**Grid Code
Modification
Recommendation Form**

Title of Recommended Proposal:
MPID 293 DSU Maximum Down Time

MPID: 293

Date:	18 February 2022
Recommended at GCRP Meeting No.:	03/2021 (Meeting dated 02 November)
Grid Code Version:	Version 9 of the Grid Code was the current version when this modification was proposed and recommended.
Grid Code Section(s) Impacted by Recommended Proposal:	CC.7.4

The various DSU performance parameters illustrated in the diagram below, taken from CC.7.4:

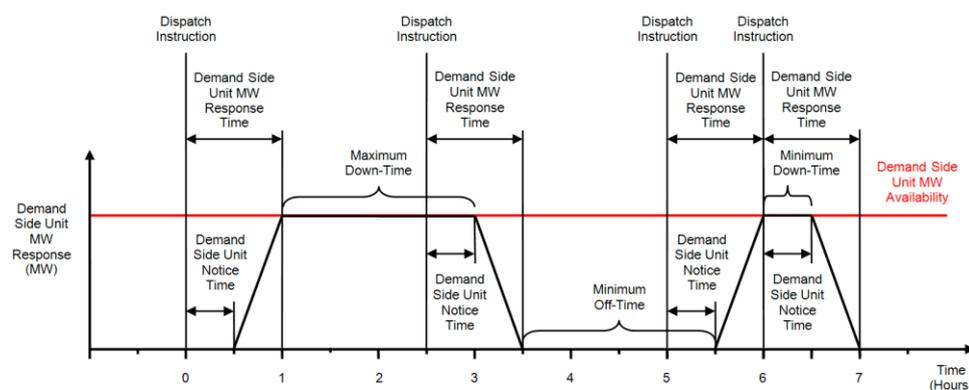
The proposed Grid Code modification would remove this restriction, so that DSUs can be created with any Maximum Down Time. Grid Code Clause CC.7.4(e) imposes the restriction. This clause is not referred elsewhere in the Grid Code. The DRAI do not propose any changes to the other requirements for DSUs in Grid Code Clause CC.7.4 are not taken into account in the Capacity Market's de-rating factor calculations.

This diagram is an example of a DSU where the Maximum Down Time is 2 hours, but this is not strictly necessary, as it is already possible to create DSUs with longer Maximum Down Times. This Grid Code modification would allow the Maximum Down Time for a DSU to be less than two hours.

- (e) ~~Maximum Down Time not less than 2 hours~~ *Not used*;

(e) *Not used;*
